Safety Recall

Code: 90S9

Subject	Gateway Control Module																									
Release Date	March 08, 2023																									
REVISION SUMMARY	Added additional sealant part number																									
Affected Vehicles

Subject: Safety Recall 90S9 – Gateway Control Module

Cover folded under the gateway.

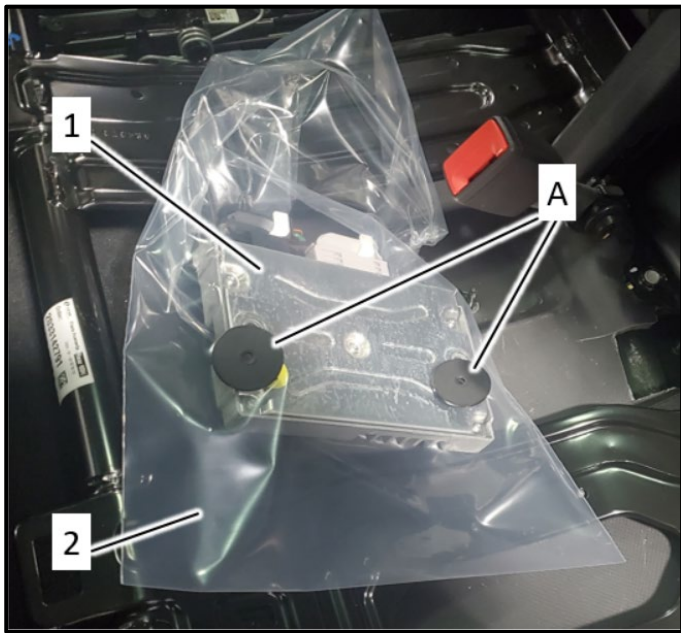
Ensure the cover is installed correctly. If the cover is folded under the gateway, it's possible to pinch the cover and create a puncture in the cover. Pay very close attention to how the cover is installed and also ensure the bolts are torqued correctly. Below are examples of covers that were not installed correctly, which can result in liquid entering the cover and damaging the gateway.

- Place the gateway control module <1> into protective cover <2>.
- The gaskets <A> will be placed over the studs on the floor.

- The gateway must be fastened with new nuts.
- Tightening the nuts must be performed inside the protective cover, as shown.
- Torque the new nuts to 5 Nm.
